UNITED STATES PATENT AND TRADEMARK OFFICE

APPLICATION NO.	FILING DATE	FIRST NAMED INVENTOR	ATTORNEY DOCKET NO.	CONFIRMATION NO.
10/673,053	09/26/2003	Rainer Bruchhaus	14580-031001	1239

Office Action Summary

REMARK / ARGUMENT

FIG. 18

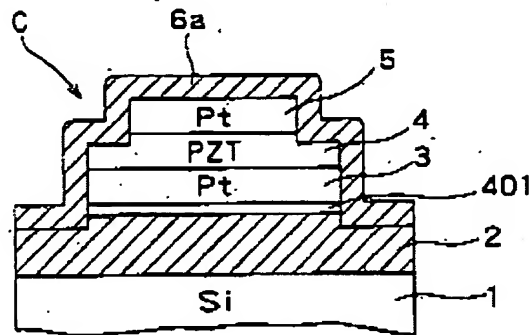
Kanaya discloses a method of forming a ferroelectric capacitor comprising forming a crystalline PZT layer as claimed. **See all the FIGS** where Kanaya teaches the following limitations

10. Pertaining to claim 1, Kanaya discloses a method of forming a ferroelectric capacitor comprising forming a crystalline PZT layer by a process including the steps of:

depositing a layer of amorphous ferroelectric material 4 over a layer of a first material 3;

etching the ferroelectric layer to form isolated ferroelectric elements (**See Fig 1 & 2, column 1 Paragraph [0018] ,please note briefly explain about etching process) ;**

providing a layer of a second material **5 & 6** on at least the side surfaces of the ferroelectric elements; and

the second material **5 & 6** promoting crystallization of the ferroelectric material to a higher degree than the first material **3**;

whereby the crystallization proceeds horizontally through the ferroelectric elements (**Please note thermal annealing process initiates to form a crystallization on ferroelectric material**) .
